# PREVOST

# SAFETY RECALL

SR23-19

DATE:	August 2023	SECTION: 06 ELECTRICAL	
SUBJECT:	FRONT RH TURN SIGNAL MALFUNCTION -		
	ADDITION OF A RESISTOR HARNESS

FIGURE 1: 0600179 RESISTOR HARNESS (CONNECTOR C60)

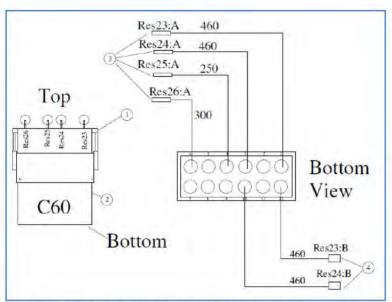
On the vehicles affected by this recall, it is necessary to add a resistor on the RH + LH turn signals as well as RH + LH low beams electrical circuits to solve an issue affecting the front RH turn signal.

Part No.	Description	Qty
0600179	RESISTOR, HARNESS (connector C60)	1
562286	TERMINAL, DEUTSCH TYPE 16 PIN 20-16AWG	2

FIGURE 7: CONNECTOR RES4 LOCATION

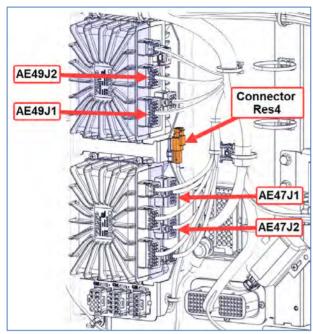
3. On the dashboard electrical control panel, find connector RES4 located between MUX modules AE49 & AE47.

- 4. Detach connector RES4 from its support and secure on nearby harness using a nylon tie.
- 5. Secure connector C60 of resistor harness 0600179 on the support in place of connector RES4.

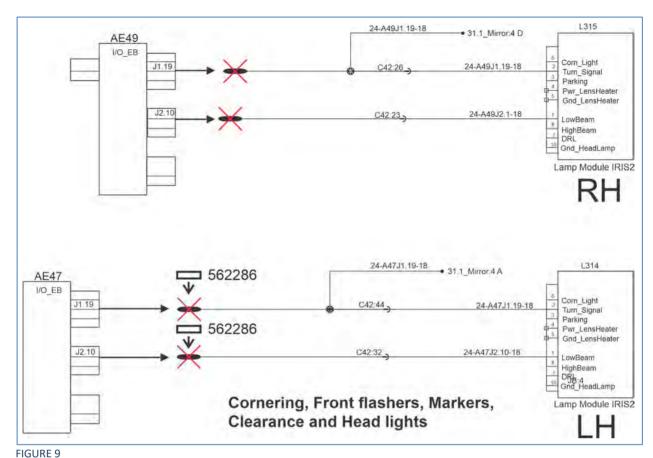
6. Disconnect the RH turn signal circuit (A49J1.19) from MUX module AE49 at J1.19. Cut and discard the terminal (Figure 9). Label this circuit "RES24B".

### FIGURE 10

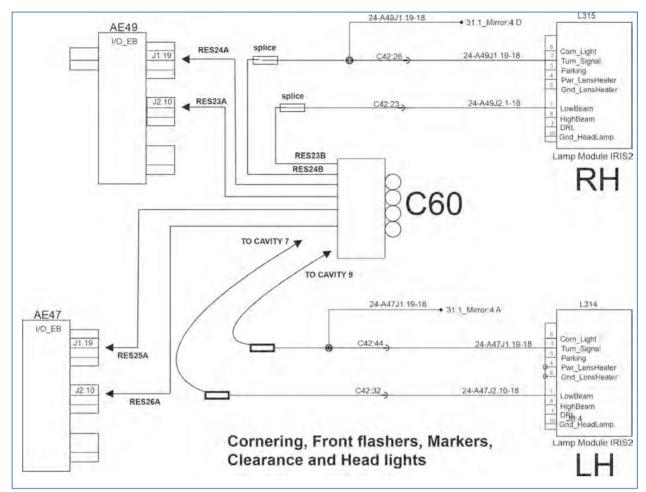
- 7. Disconnect the RH low beam circuit (A49J2.10) from MUX module AE49 at J2.10. Cut and discard the terminal (Figure 9). Label this circuit "RES23B".
- 8. Disconnect the LH turn signal circuit (A47J1.19) from MUX module AE47 at J1.19. Cut terminal and replace with terminal 562286 included in kit (Figure 9). Label this circuit "RES25B".
- 9. Disconnect the LH low beam circuit (A47J2.10) from MUX module AE47 at J2.10. Cut terminal and replace with terminal 562286 included in kit (Figure 9). Label this circuit "RES26B".

- 10. Insert wire RES24A from C60 into AE49J1.19.
- 11. Splice the newly labeled RES24B to RES24B wire from C60.
- 12. Insert wire RES23A from C60 into AE49J2.10.
- 13. Splice the newly labeled RES23B to RES23B wire from C60.
- 14. Insert wire RES25A from C60 into AE47J1.19.
- 15. Insert wire RES26A from C60 into AE47J2.10
- 16. Connect newly labeled RES25B to cavity 9 of C60.
- 17. Connect newly labeled RES26B to cavity 7 of C60.
- 18. Secure all the wires to nearby harness using nylon ties.
- 19. Confirm the proper functioning of the new installation. Test the following items:
